**BROOKWOODS  
SUBDIVISION**

HARWINTON,  
CONNECTICUT

### **Environmental Review Team Report**

Harwinton Inland Wetlands Commission

**Proposed Site Plan**

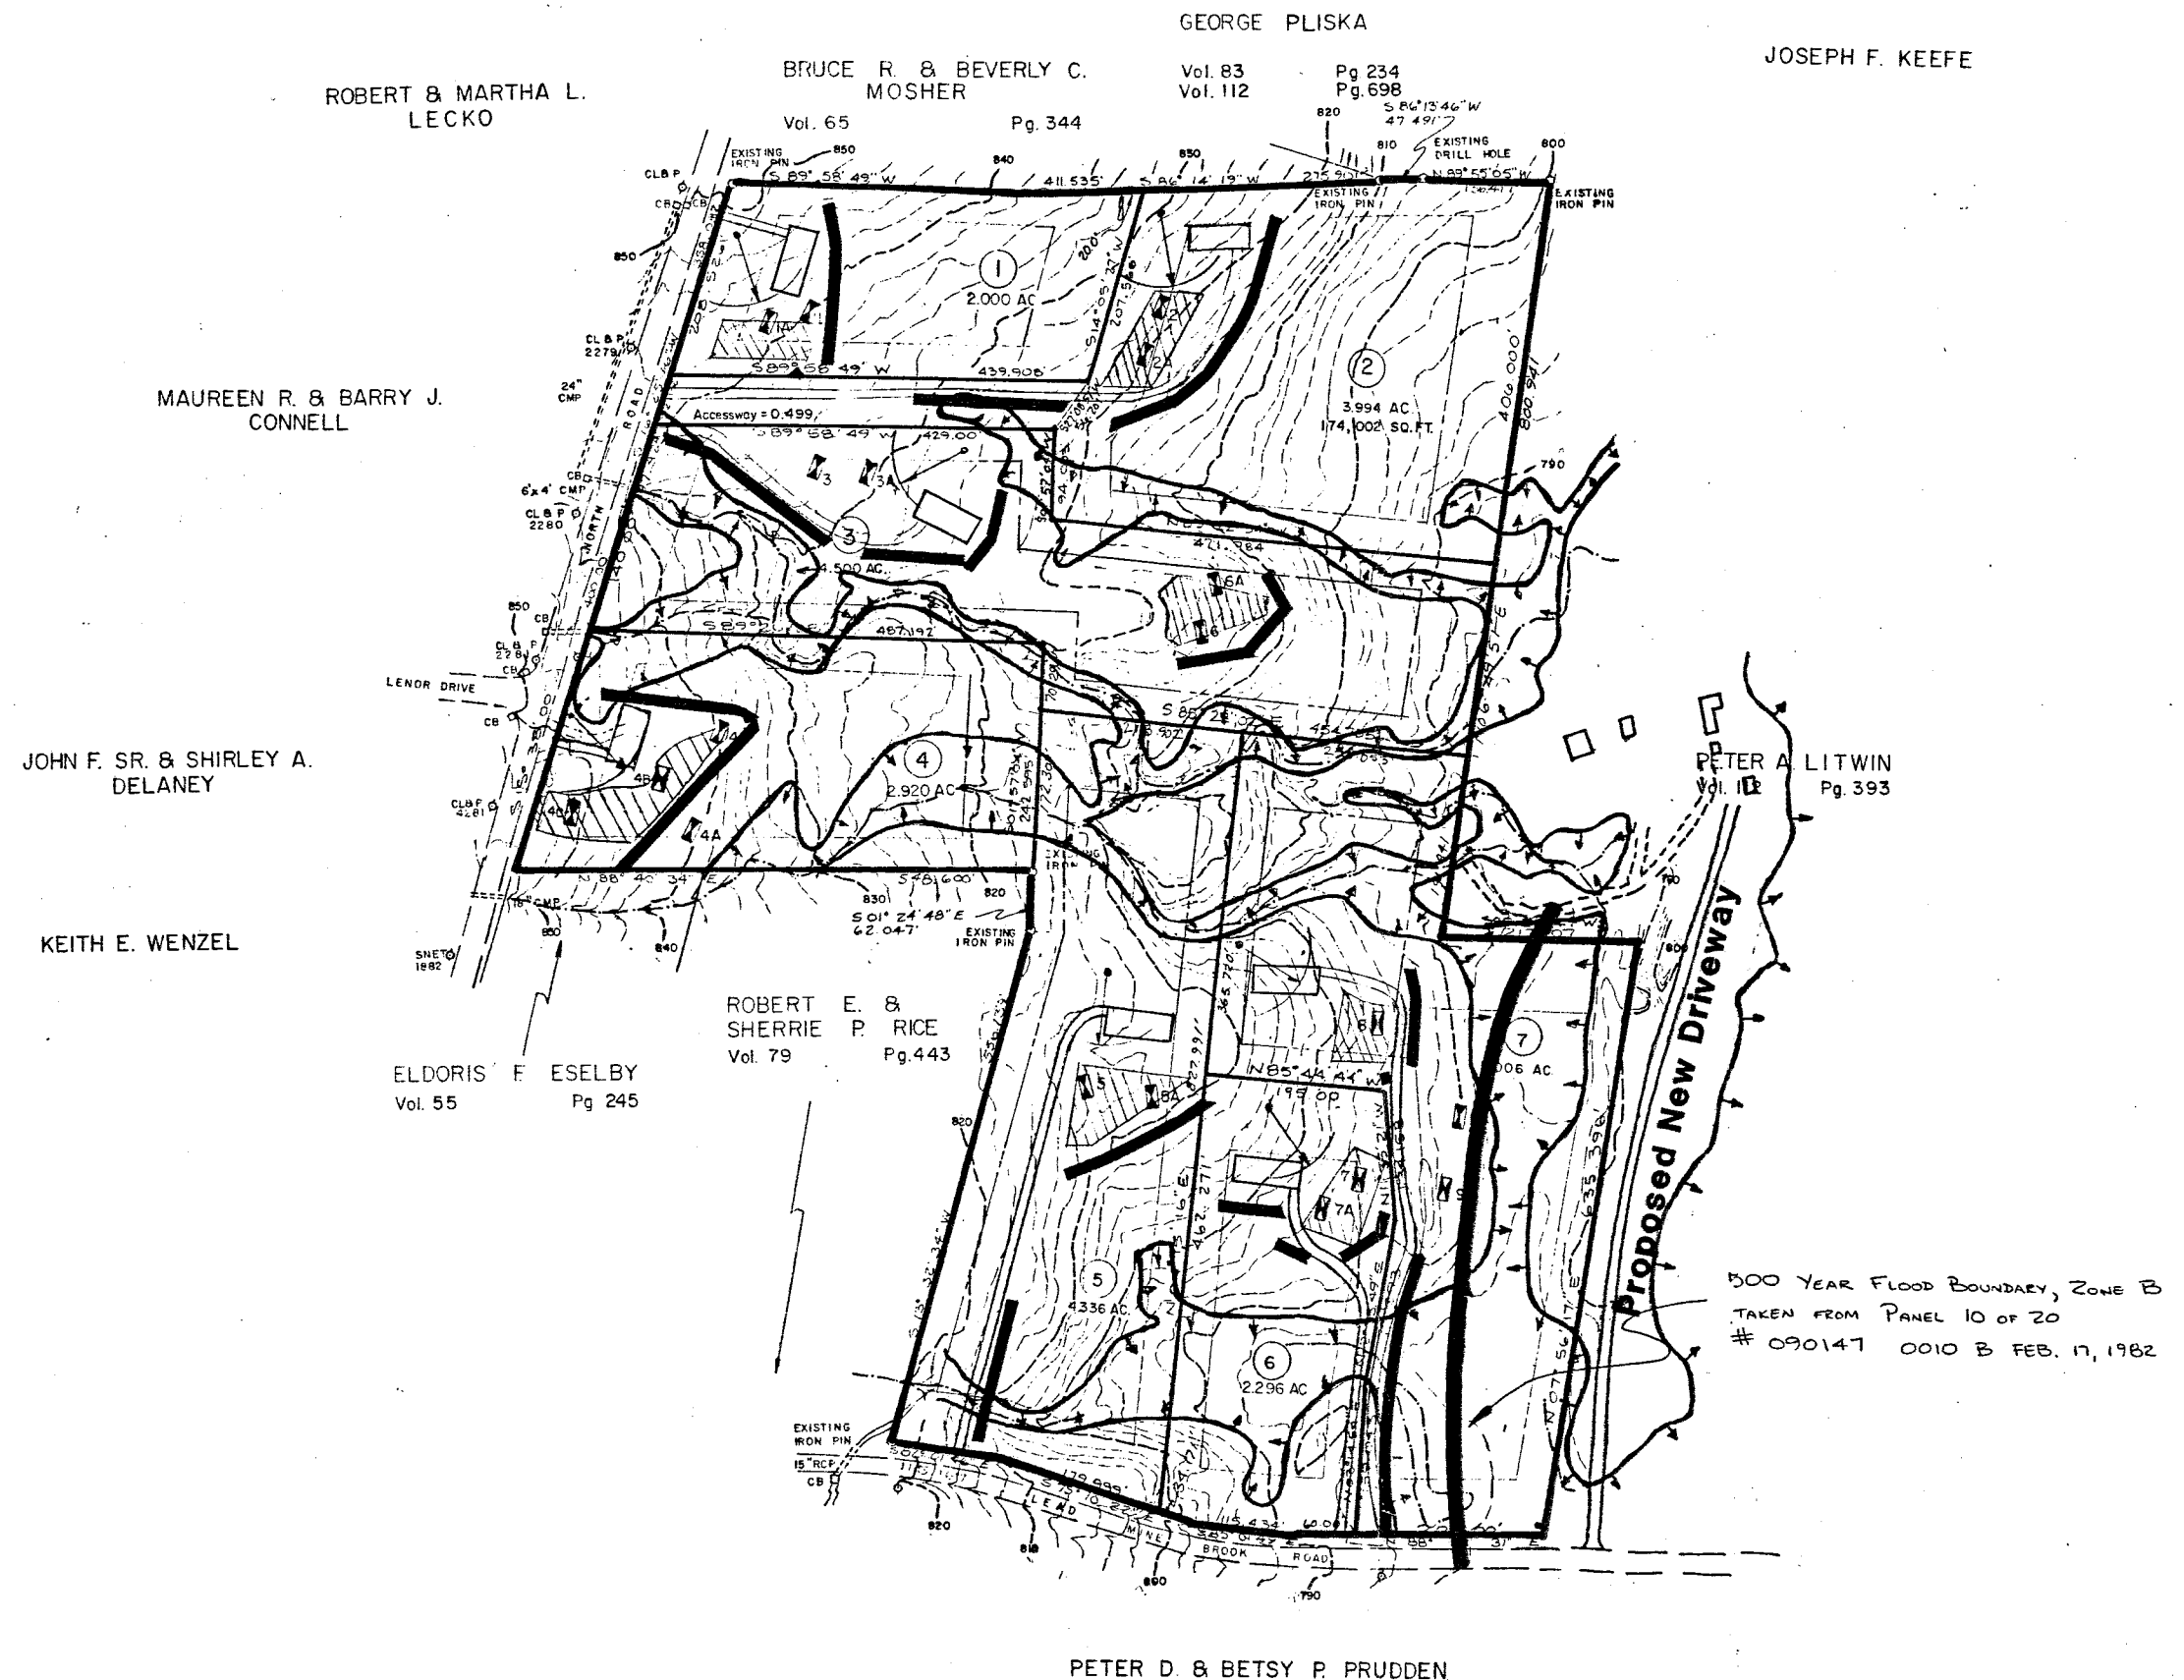
The proposed subdivision calls for four wetland driveway crossings on Lots 3, 5, 6 and 7. Additionally, it appears that grading for the driveway serving Lot 2 may also infringe upon wetlands. An existing driveway serving a residence west of the site,

which presently traverses Lot 4, will be relocated west of the proposed Lot 7 via Leadmine Brook Road. According to the Flood Insurance Rate Map for Harwinton (February 17, 1982), the latter driveway would have to traverse a Zone B area. Zone B areas are defined as those areas between limits of the 100-year flood and 500-year flood; or certain areas subject to 100-year flooding with average depths less than 1 foot or where the contributing drainage area is less than 1 square mile; or areas protected by levees from the base flood. As such, the Zone B area has natural flood detention capabilities. Filling in that area for the driveway will take away the existing flood detention capabilities of floodplain. Also, if the driveway is inundated during a flood event, vehicular traffic (i.e., emergency vehicles, etc.) may be cut off to the house. Town officials need to study this proposed crossing very carefully from a hydrologic and safety standpoint.

If wetland crossings are permitted, every effort should be made to restrict the crossing activity to the dry time of year, when water tables are low. This should minimize the chance for erosion and sedimentation problems. Also, if local zoning permits, the potentially adverse impacts to wetlands in the area of Lots 6 and 7 could be reduced by combining the 2 driveways.

Lastly, there is the issue of relocating the existing driveway which presently crosses the proposal site, from North Road, and accesses the property to the west of Lots 3 and 7, adjacent to the brook. Reference was made to eliminating the existing driveway and creating a new access drive off of Leadmine Brook Road, just to the west of Lot 7. This proposed relocation is within the boundaries of the 500-year flood plain of the FEMA flood insurance rate map, and would require an additional crossing of a watercourse and its associated wetlands. Since any relocation of the existing driveway will result in unavoidable wetland impacts and since the proposed project will be the cause of this relocation and subsequent impacts, it is

recommended that the Wetland Commission require the applicant to address this issue within the context of this application and not allow the issues to be separated. If the Commission allows these issues to be separated it may, in effect, eliminate possible alternatives to the relocation issue. With respect to the proposed relocation site for the driveway, the additional wetland impacts should be closely examined by the commission in light of feasible and prudent alternatives.

- 1) There are three direct wetland encroachments and/or impacts proposed within the application, all as a result of driveway access. The proposed driveways for Lots 2 and 5 will not create any significant impacts, providing that best management practices are used during construction activities and banks are stabilized as soon as possible after the completion of the work. The access proposed for Lots 6 and 7 should consider the use of a dual access driveway and seek a waiver to any planning and zoning requirements which may inhibit the use of such an alternative.

- 3) The local commissions should include the issue of relocating the existing driveway to the property west of Lots 3 and 7 within the subdivision application. In order to evaluate, and have available, all feasible and prudent alternatives, no permit should be issued until a solution to this matter is decided upon.

Soils

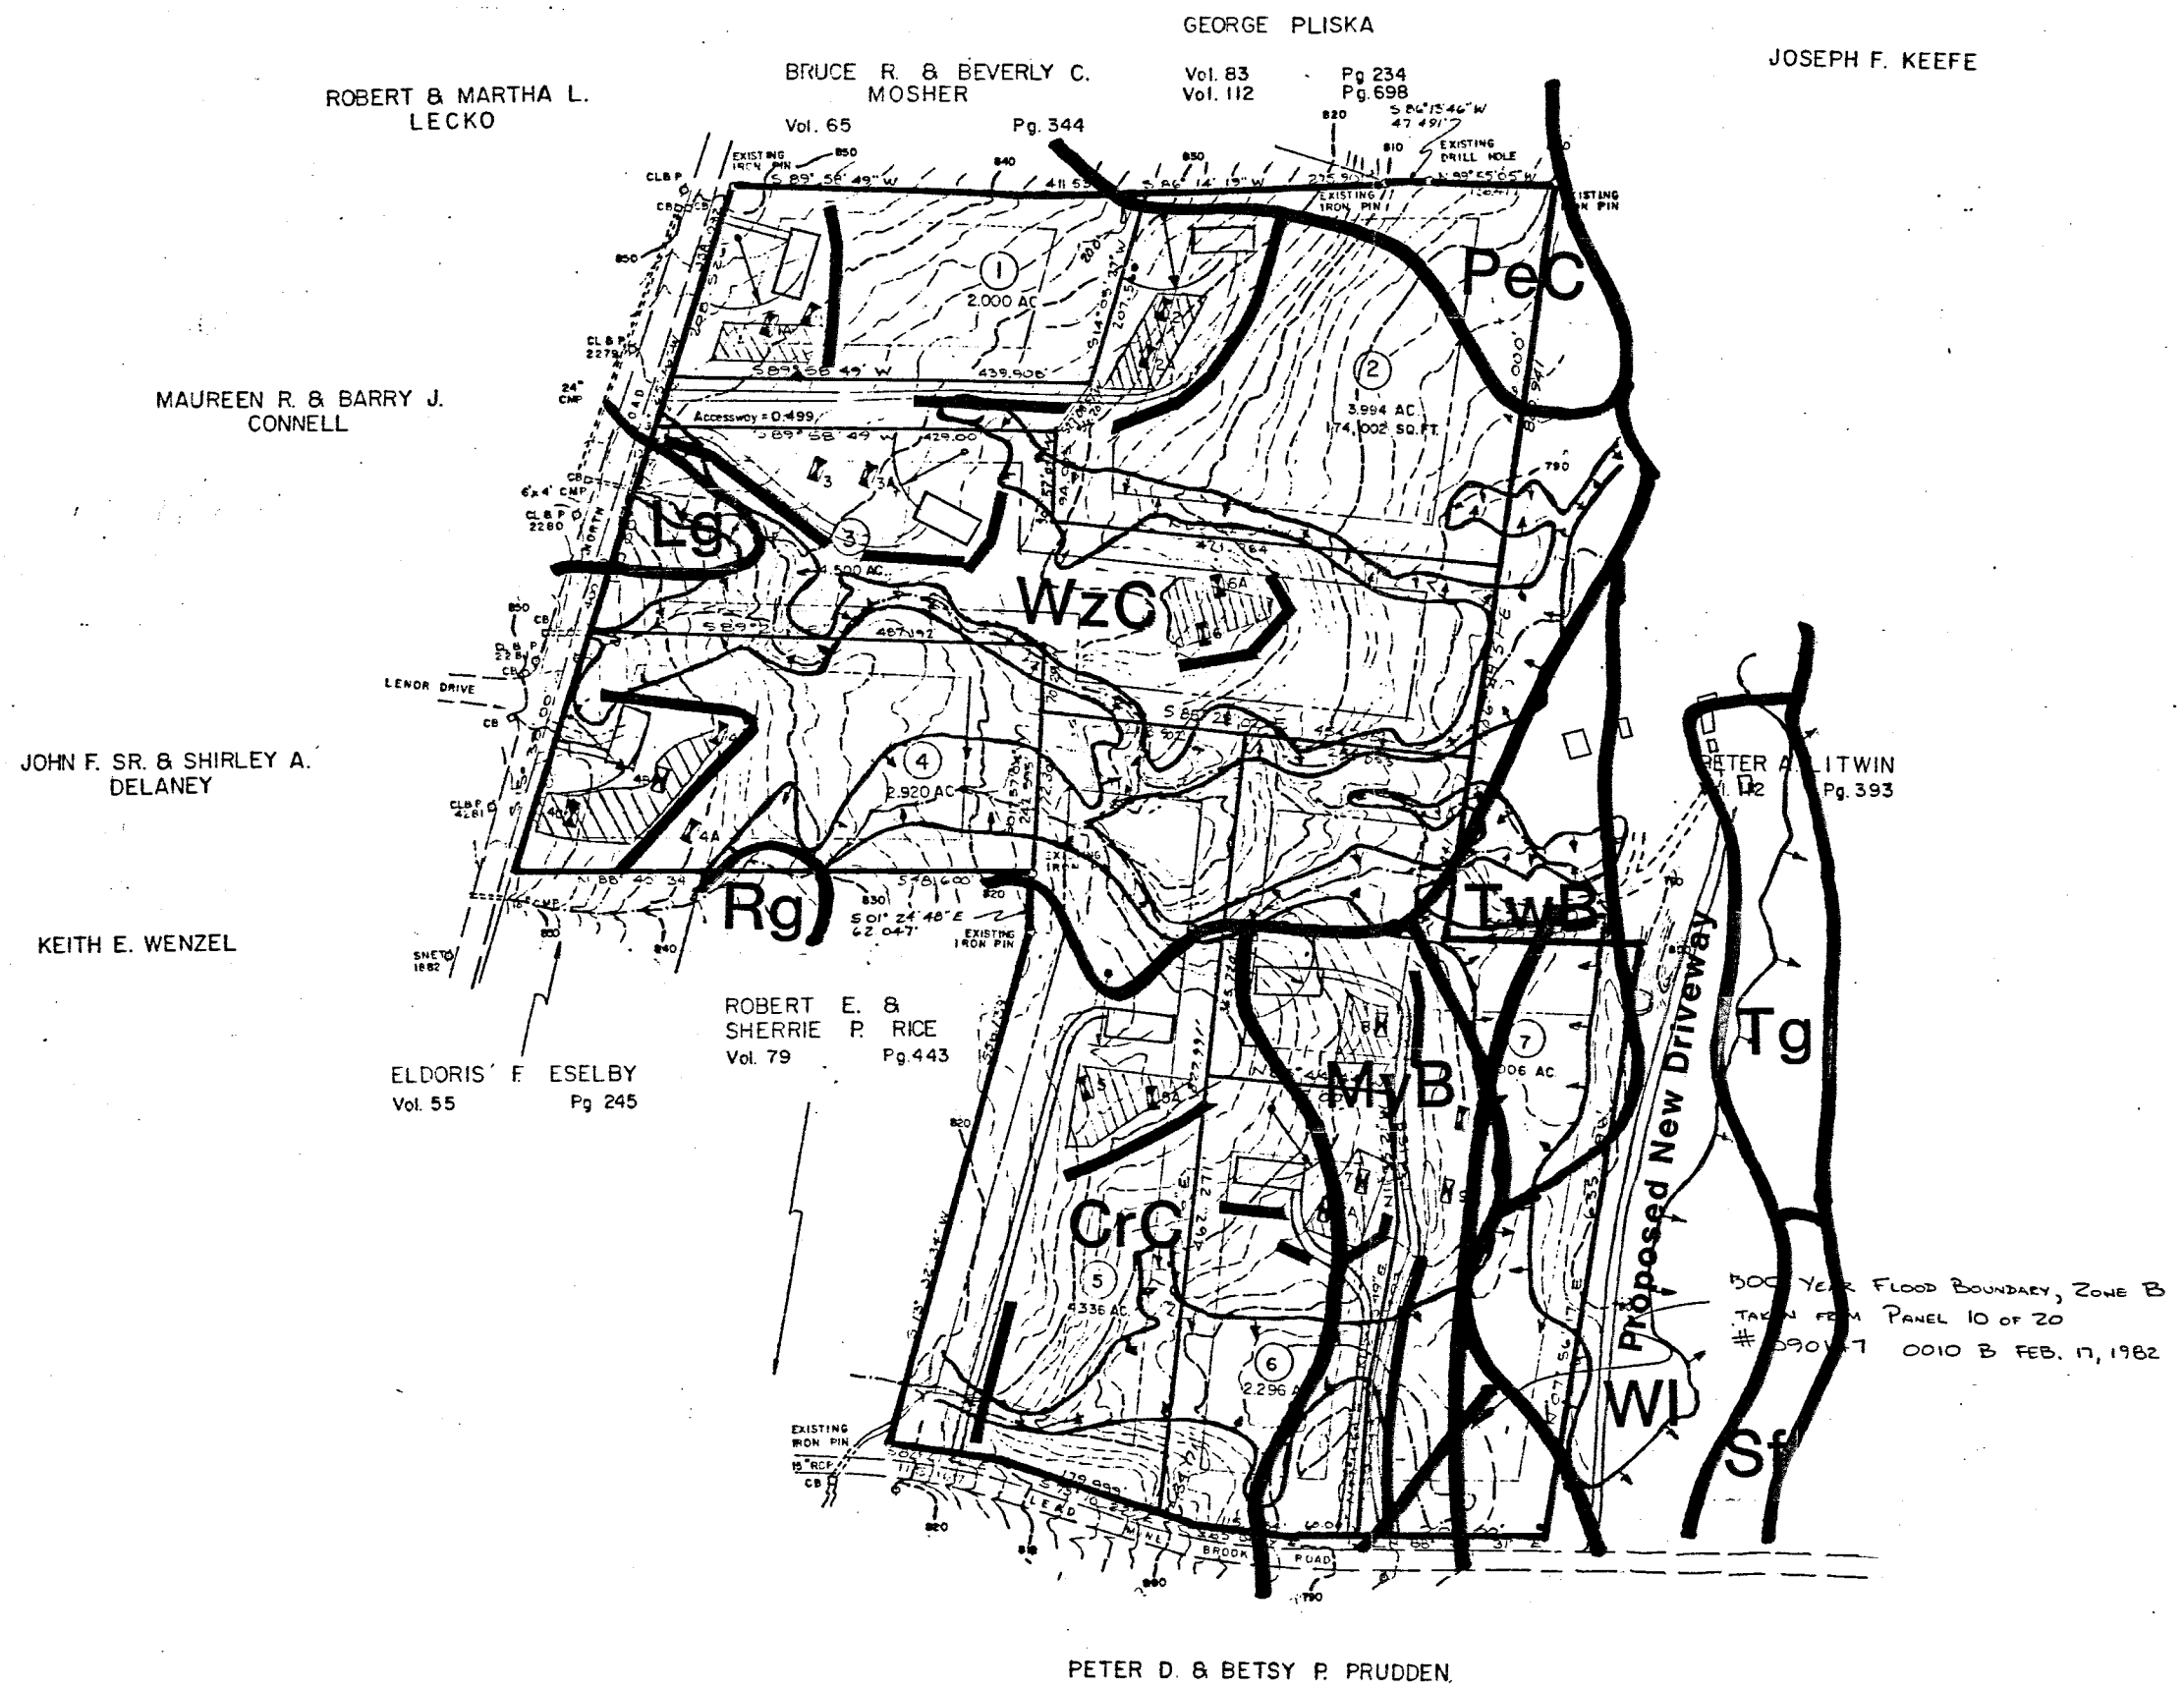
- d) The proposed driveway adjacent to lot number 7, but outside the proposed subdivision, is totally within the 500-year flood boundary associated with Leadmine Brook. According to the definition of Zone B of the flood insurance rate map for Harwinton, certain areas within this 500-year flood boundary may also be subject to 100-year flooding. It is recommended that further research be conducted to establish previous 100-year flooding levels (if available) for consideration of, but not limited to, road construction.
- 2) Provide specific seeding information such as, but not limited to, seeding dates, seed mixture, etc., directly on the plan. The recommended seeding dates for establishing permanent vegetative cover include:
